R4B Supplementary Design Statement for S4.55 MOD

Renzo Piano Building Workshop | One Sydney Harbour | Design Report | June 2021

R4B SUPPLEMENTARY DESIGN STATEMENT FOR S4.55 MODIFICATION APPLICATION  
June 2021

Proposed Ground Floor Plan

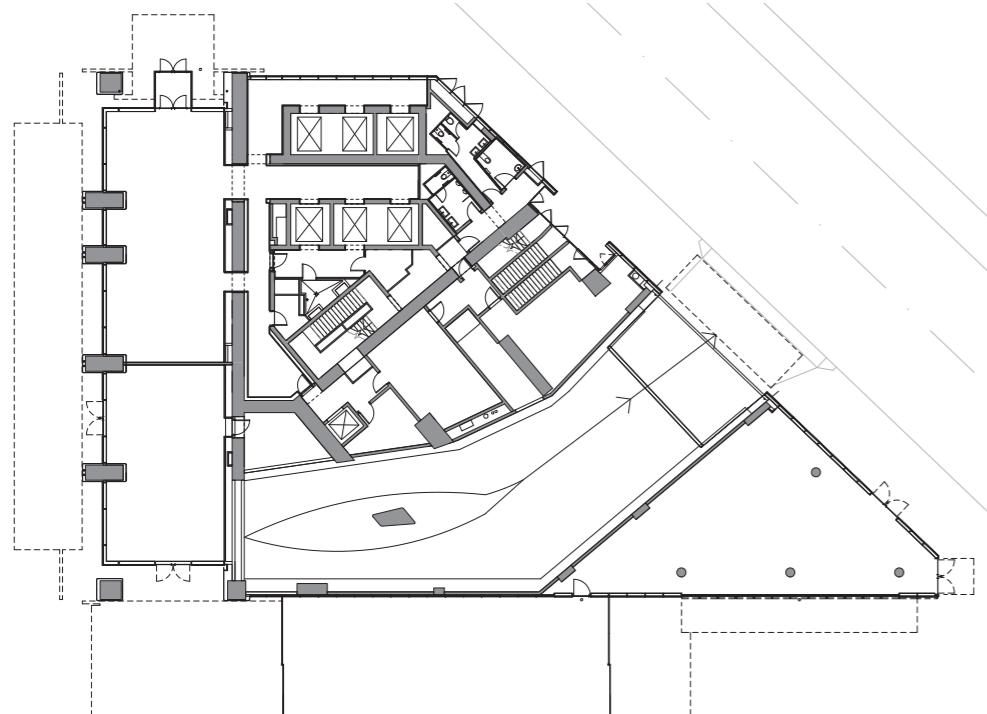
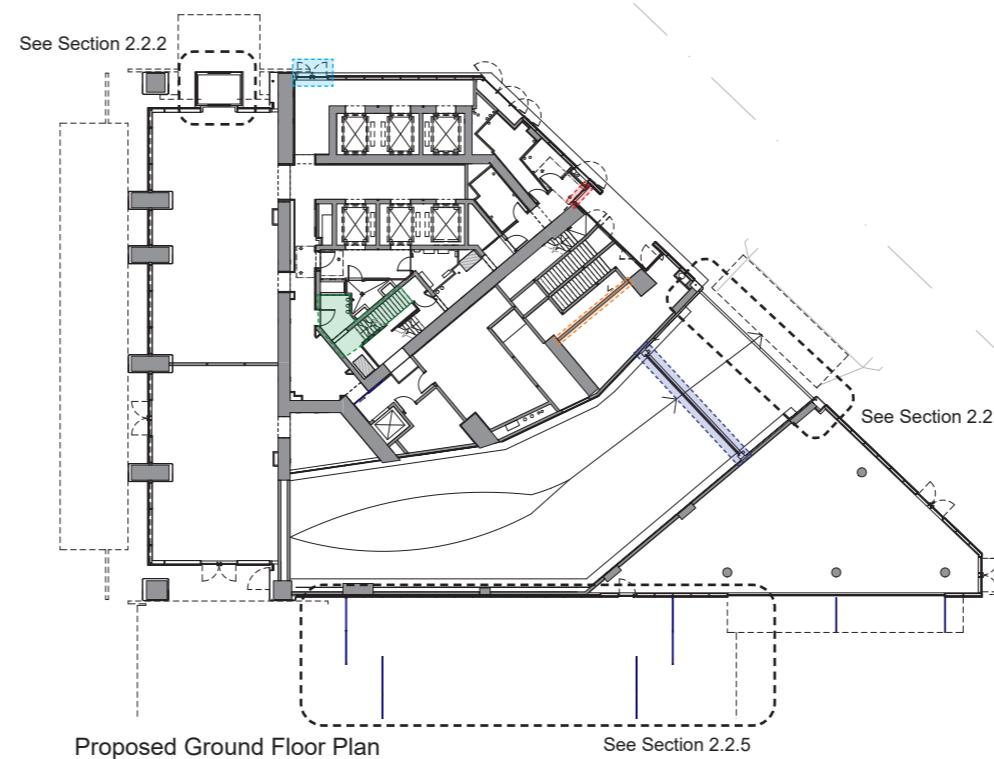
See Section 2.2.5

Proposed Level 01 Floor Plan

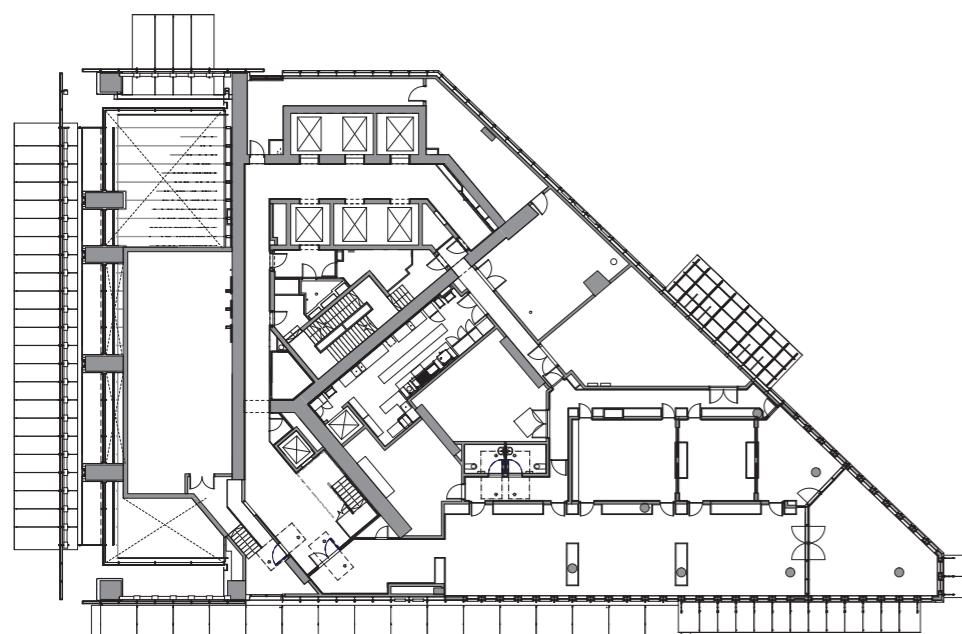
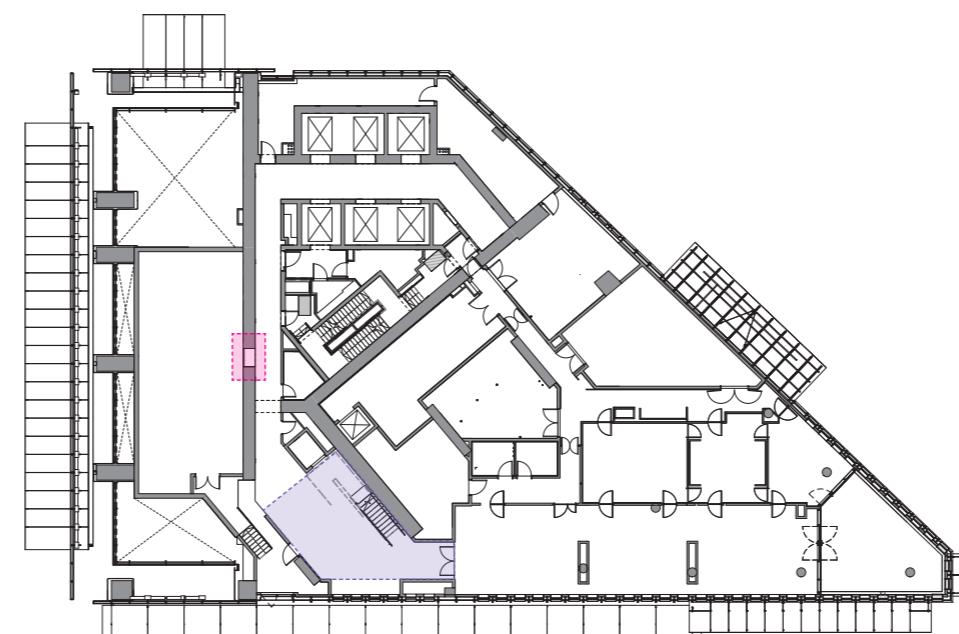
Minor changes are proposed for the ground floor and level 1 floor plans. These changes are predominantly a response to building compliance reviews that has occurred through design development (such as the provision of second egress pathways), design developments (such as the fine tuning of the car park entry ramp door location) and general design improvements.

- Addition of a secondary lobby exit (double pivot doors)
- Entry modified to adopt a sliding door system
- Wall added for new stair pressurisation plant
- Carpark entry ramp door location fine tuned
- Egress pathway added and store room removed
- Second egress added to mezzanine plantroom
- Door adjusted, amenity stairs adjusted, store room removed

Proposed Level 02 Floor Plan

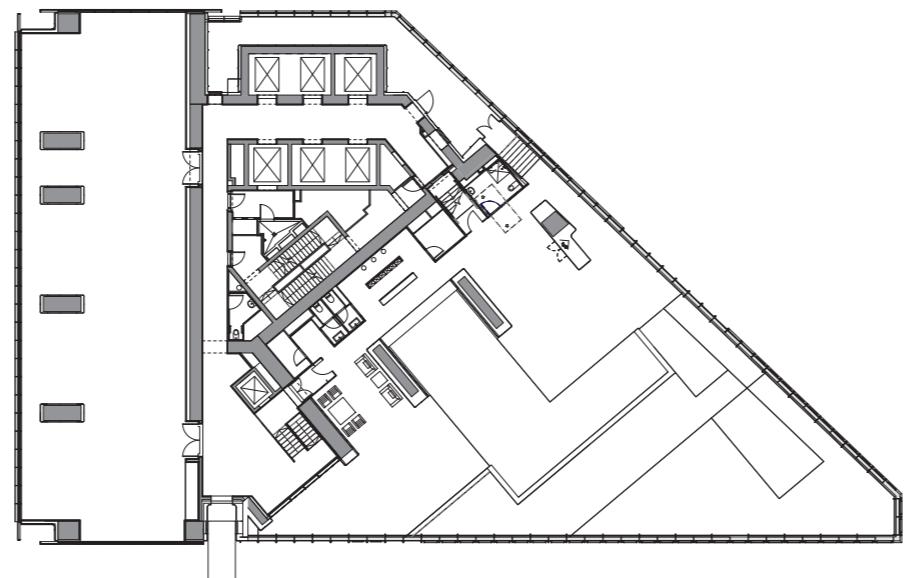
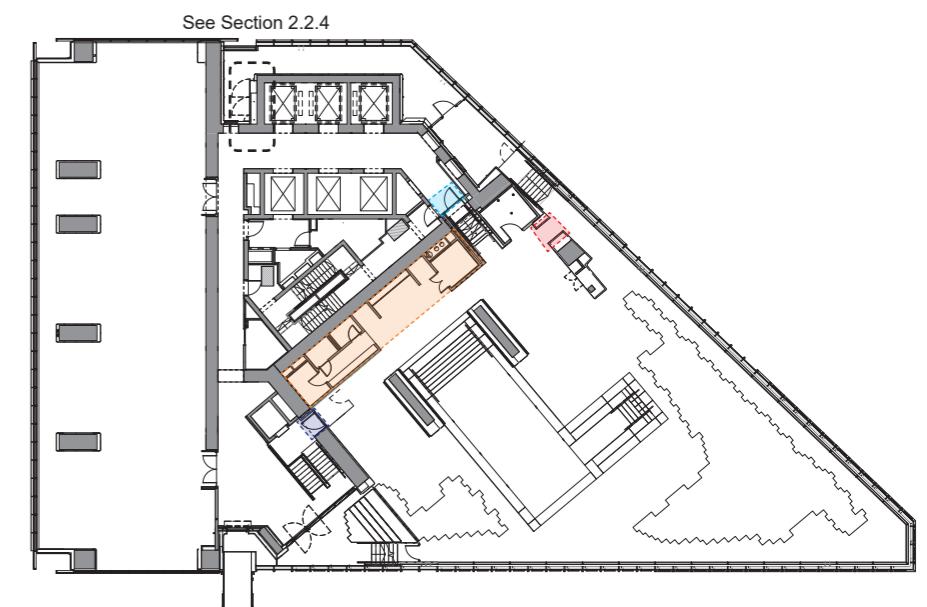
Changes to the Level 02 floor plan include minor improvements to the bathing amenities layout, the width and alignment of the portal highlighted in red, and changes to the door types in the highlighted accessways to the swimming pool terrace.

- Sliding door changed to swing door
- Facade updated
- Shower area and amenities changed
- Double door changed to single door

Proposed Entry vestibule - Plan

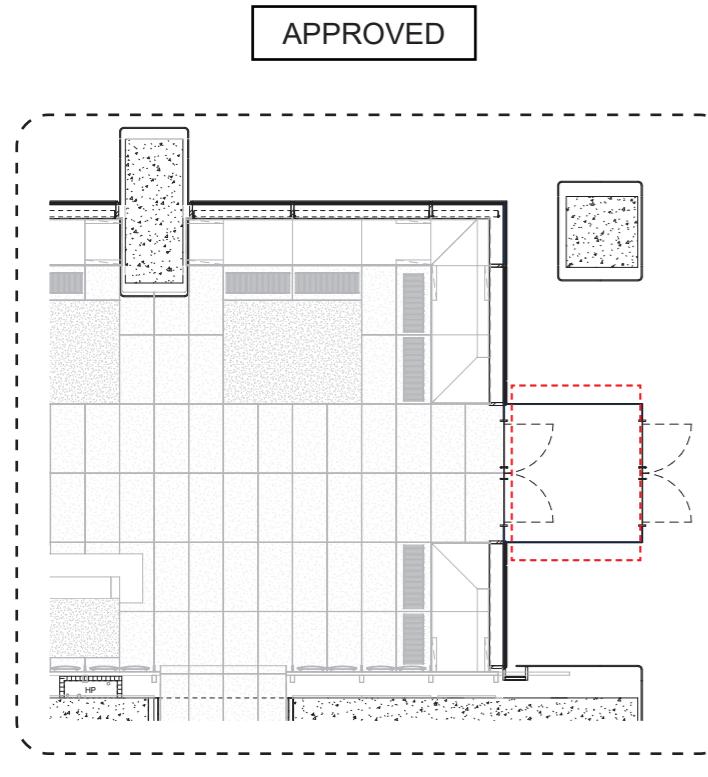
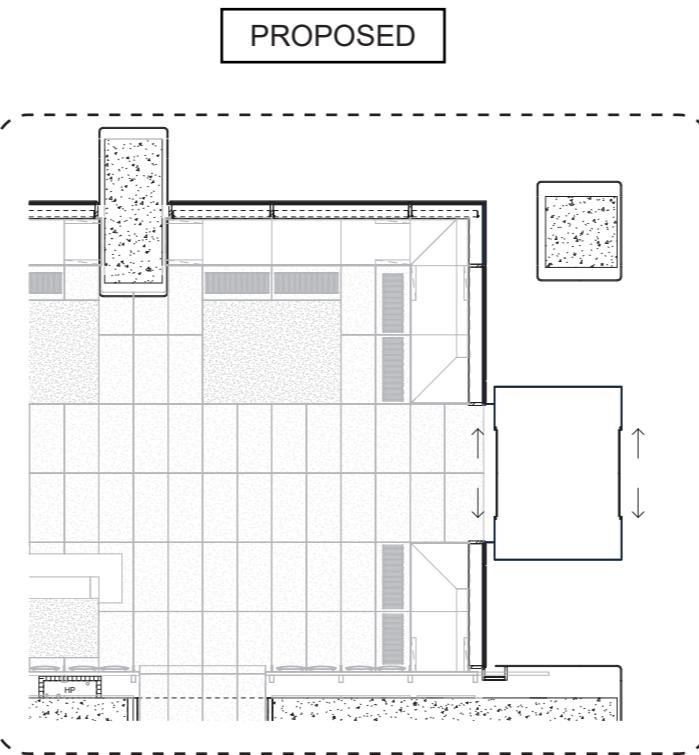
Automated sliding doors have been integrated in lieu of swing doors, improving operability as well as creating a seamless transition from outside to the residential lobby interior.

Through detailed review with the project consultant team, it has been determined that a sliding door system would provide a more robust, reliable and fit-for-purpose solution.

This amendment has resulted in a minor adjustment to the dimensions of the lobby vestibule. This amendment has been integrated into the modulation, proportion and geometry of the facade to provide a design response that meets the design standards of the precinct architecture.

Proposed Entry vestibule - 3D View

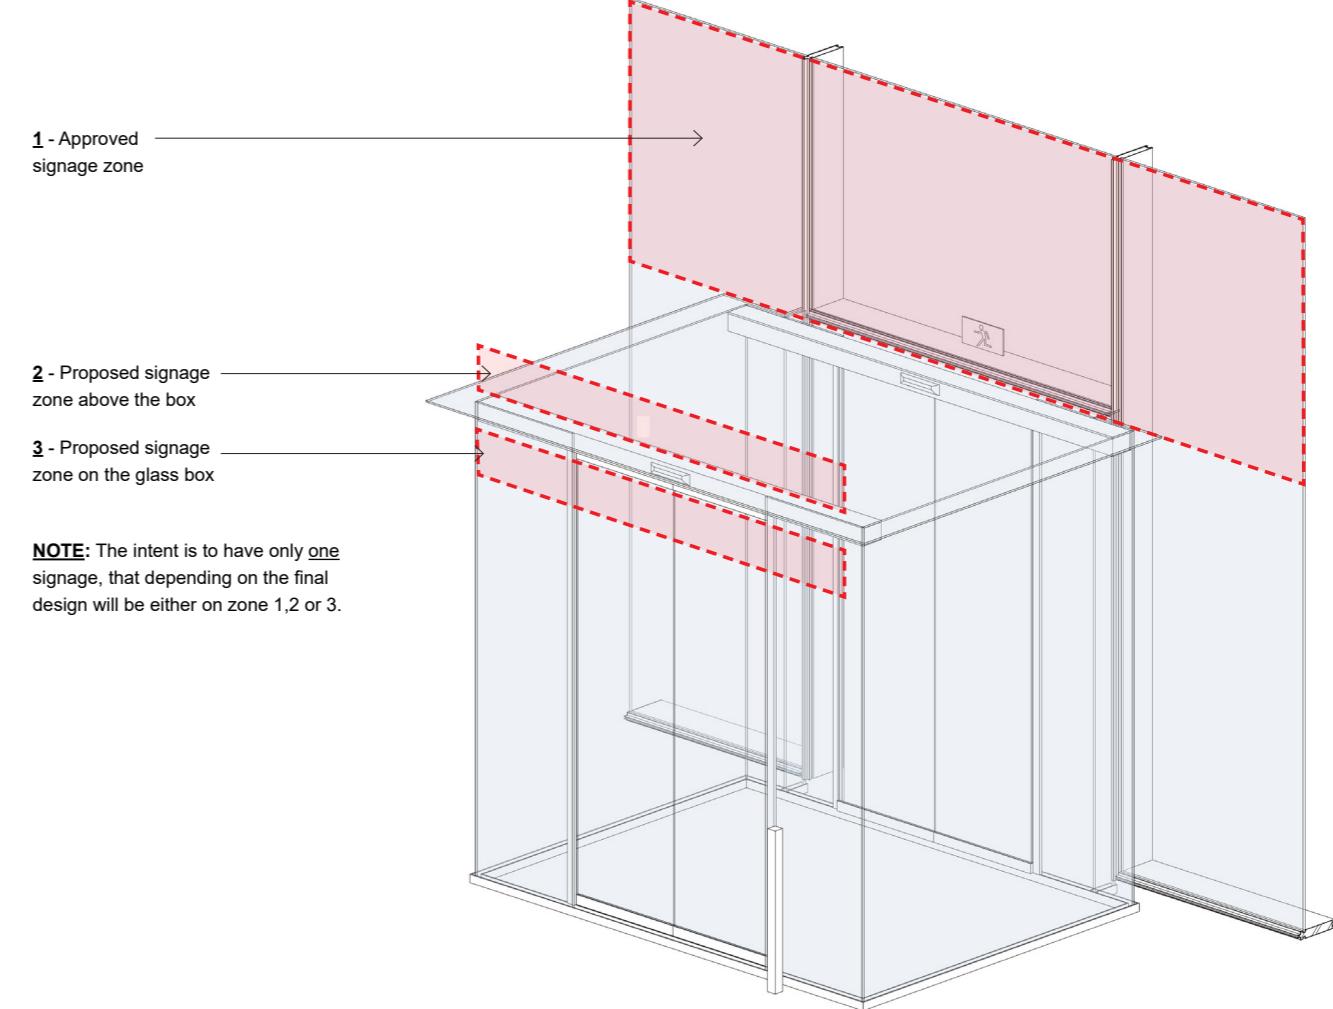
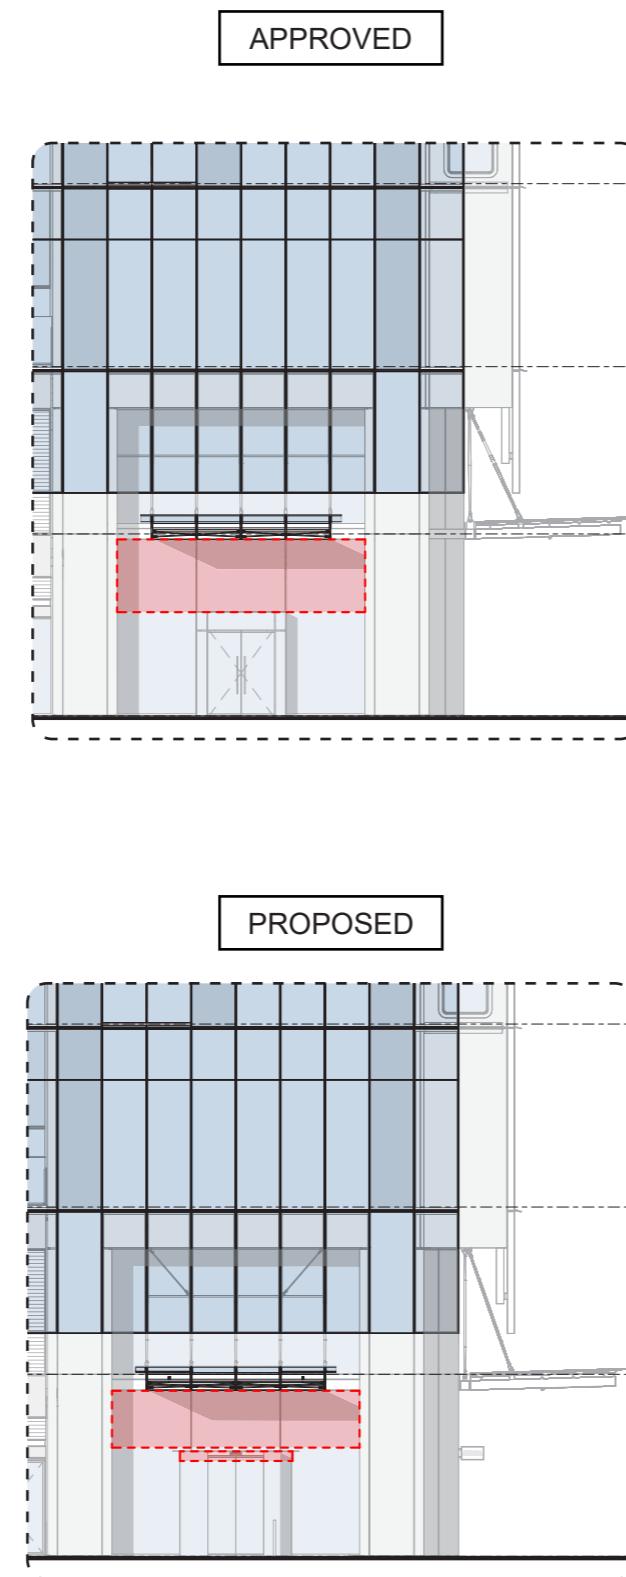
Further detailed development on building signage has been undertaken and it is proposed to revise the location of the entry vestibule signage zone as shown on the right.

The already approved zone above the entry vestibule box has been extended to include a potential signage on the glass above the door.

Depending on the final design the signage may be located either on the glass or above the vestibule volume.

Proposed P02 Floor Plan and Vent pipe zone Blow-up

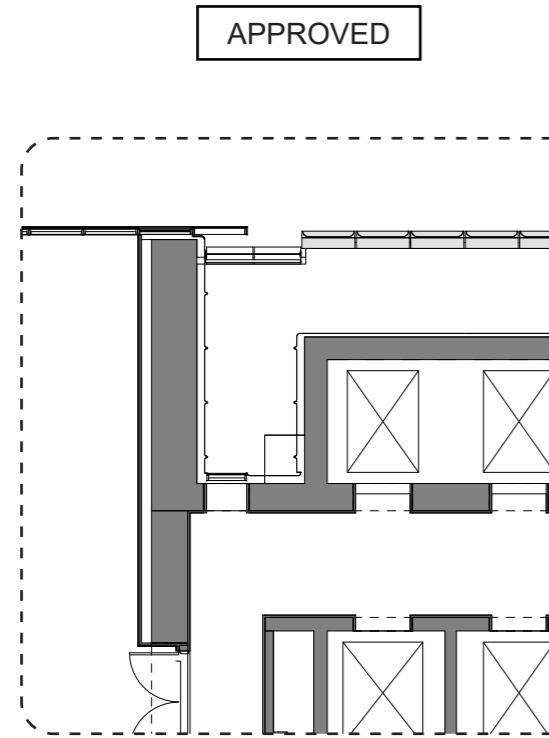
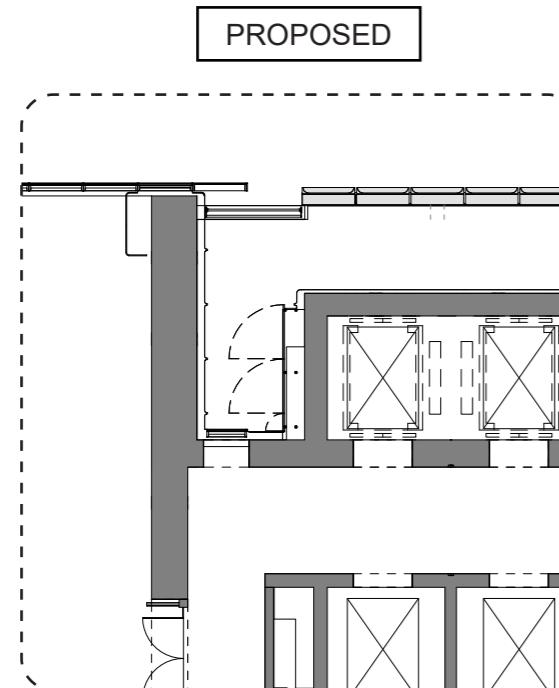
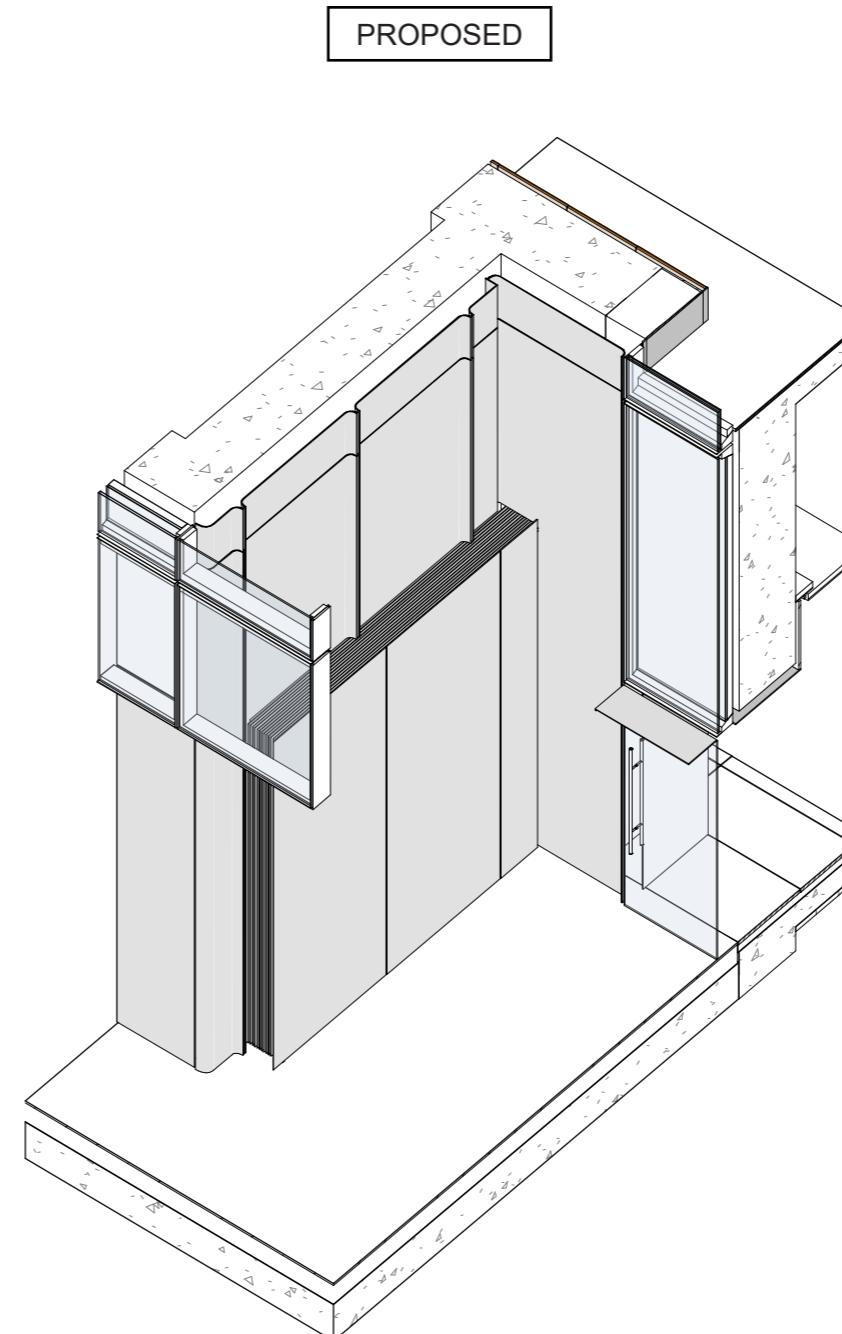
An amendment is also proposed to the vent pipes on P02 level close to the south east lift core facade.

The approved box flue solution was reworked to better reflect the design of the facade. The proposed scheme has the pipes arranged inside a cabinet-like structure, preserving the facade modularity and finishes, resulting in a visually integrated outcome.

This change was also driven by the aim to increase the clear width leading up to the window in that area.
